Proposal for new 03 series of amendments to UN Regulation No. 117 (Tyre rolling resistance, rolling noise and wet grip)

Submitted by the Working Party on Noise and Tyres*

The text reproduced below was adopted by the Working Party on Noise and Tyres (GRBP) at its seventy-fourth and seventy-fifth sessions (ECE/TRANS/WP.29/GRBP/72, para. 23 and ECE/TRANS/WP.29/GRBP/73, para. 21). It replaces ECE/TRANS/WP.29/2022/11 and is based on ECE/TRANS/WP.29/GRBP/2021/12 and informal documents GRBP-74-33-Rev.1 and GRBP-75-25-Rev.1. It is submitted to the World Forum for Harmonization of Vehicle Regulations (WP.29) and to the Administrative Committee (AC.1) for consideration at their June 2022 sessions.

Example 1

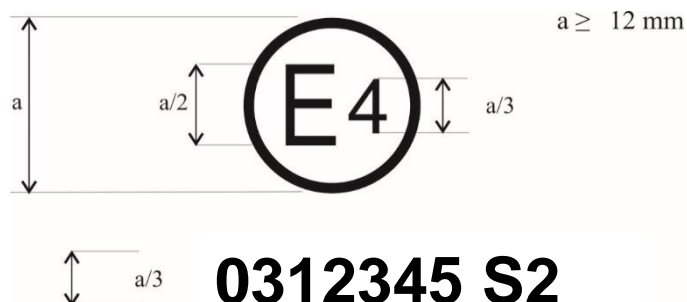
The above approval mark, affixed to a tyre shows that the tyre concerned has been approved in the Netherlands (E4) pursuant to UN Regulation No. 117 (marked by S2 (rolling sound emission at stage 2)), under approval number 0312345. The first two digits of the approval number (03) indicate that the approval was granted according to the requirements of the 03 series of amendments to this Regulation.

Example 2

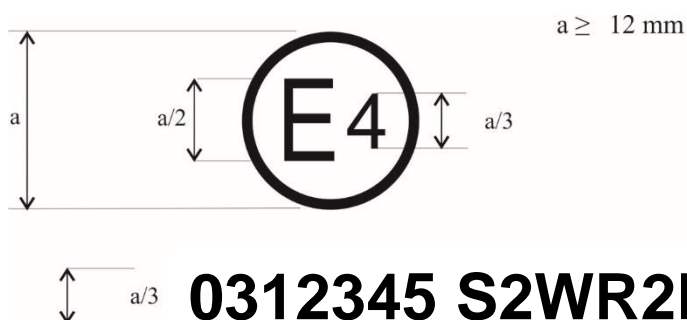
The above approval mark shows that the tyre concerned has been approved in the Netherlands (E4) pursuant to UN Regulation No. 117 (marked by S2 (rolling sound emission at stage 2), W (wet adhesion of tyres in new state), R2 (rolling resistance at stage 2) and B (wet adhesion of tyres in worn state)) under approval number 0312345. The first two digits of the approval number (03) indicate that the approval was granted according to the requirements of the 03 series of amendments to this Regulation."

Example 1

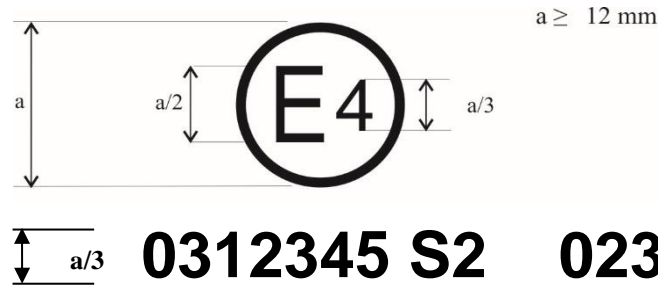
The above approval mark shows that the tyre concerned has been approved in the Netherlands (E4) pursuant to UN Regulation No. 117 (marked by "S2" (rolling sound emission at stage 2)), under approval number 0312345 and UN Regulation No. 30, under approval number 0236378. The first two digits of the approval numbers ("03" and "02") indicate that the approval pursuant to UN Regulation No. 117 was granted according to the 03 series of amendments and the approval pursuant to UN Regulation No. 30 according to the 02 series of amendments.

Example 2

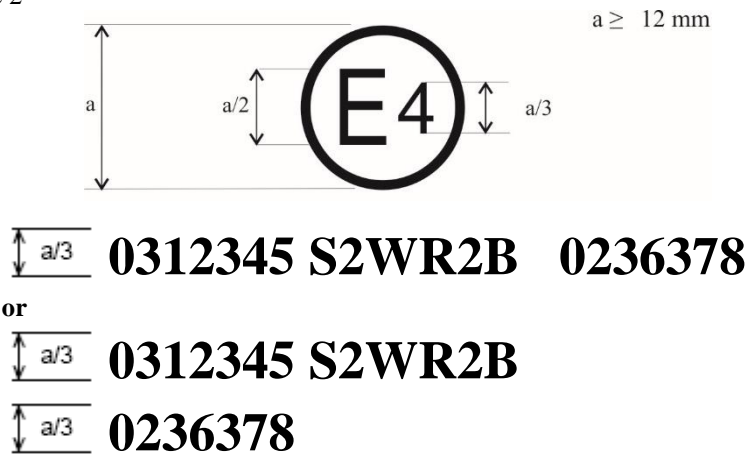
The above approval mark shows that the tyre concerned has been approved in the Netherlands (E4) pursuant to UN Regulation No. 117 (marked by "S2WR2B" (rolling sound emission at stage 2, wet adhesion of tyres in new state, rolling resistance at stage 2 and wet adhesion of tyres in worn state)), under approval number 0312345 and UN Regulation No. 30 under approval number 0236378. The first two digits of the approval numbers ("03" and "02") indicate that the approval pursuant to UN Regulation No. 117 was granted according to the 03 series of amendments and the approval pursuant to UN Regulation No. 30 according to the 02 series of amendments.

Example 3

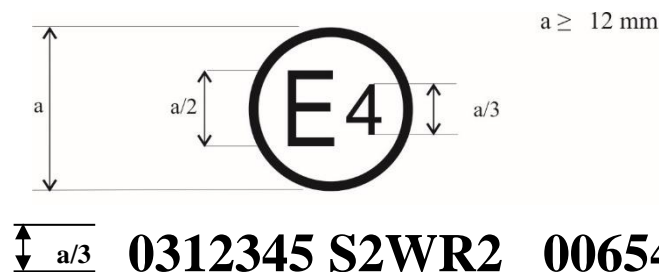
The above approval mark shows that the tyre concerned has been approved in the Netherlands (E4) pursuant to UN Regulation No. 117 (marked by "S2WR2" (rolling sound emission at stage 2, wet adhesion of tyres in new state and rolling resistance at stage 2)), under approval number 0312345 and UN Regulation No. 54 under approval number 0065432. The first two digits of the approval numbers ("03" and "00") indicate that

the approval pursuant to UN Regulation No. 117 was granted according to the 03 series of amendments and the approval pursuant to UN Regulation No. 54 according to its original form."

Example 1

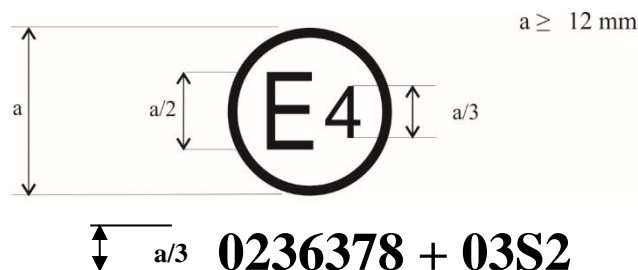
The above approval mark shows that the tyre concerned has been approved in the Netherlands (E4) pursuant to UN Regulation No. 30 according to its 02 series of amendments (indicated by the first two digits of the approval number, "02") under approval number 0236378. It is also marked by "+ 03S2" which indicates that the tyre was also approved pursuant to UN Regulation No. 117 (03 series of amendments) for S (rolling sound emission at stage 2).

Example 2

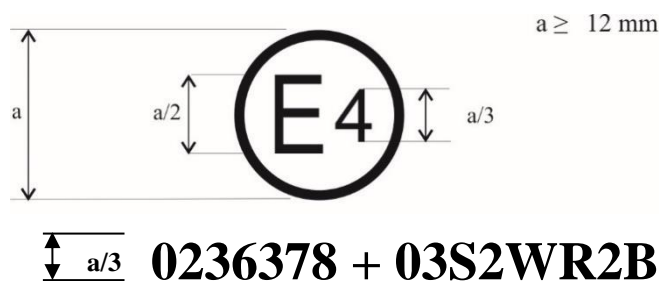
The above approval mark shows that the tyre concerned has been approved in the Netherlands (E4) pursuant to UN Regulation No. 30 according to its 02 series of amendments (indicated by the first two digits of the approval number, "02") under approval number 0236378. It is also marked by "+ 03S2WR2B" which indicates that the tyre was also approved pursuant to UN Regulation No. 117 (03 series of amendments) for S (rolling sound emission at stage 2) W (wet adhesion of tyres in new state), R (rolling resistance at stage 2) and B (wet adhesion of tyres in worn state)."

Example 1

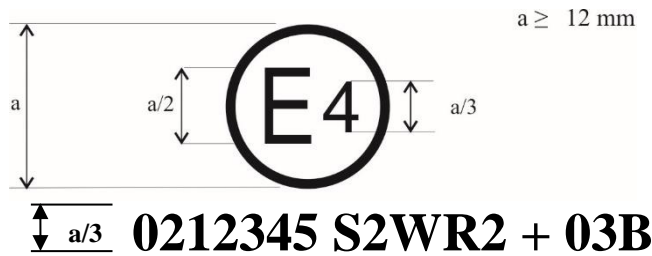
The above approval mark shows that the tyre concerned has been initially approved in the Netherlands (E4) pursuant to UN Regulation No. 117 and the 02 series of amendments under approval number 0212345. The marking is complemented by S2WR2 (rolling sound emission at stage 2) W (wet adhesion of tyres in new state) and R (rolling resistance at stage 2). The "03B" preceded by "+" indicates that it has had its approval extended under UN Regulation No. 117 and 03 series of amendments to wet adhesion of tyres in worn state based on separate certificate."
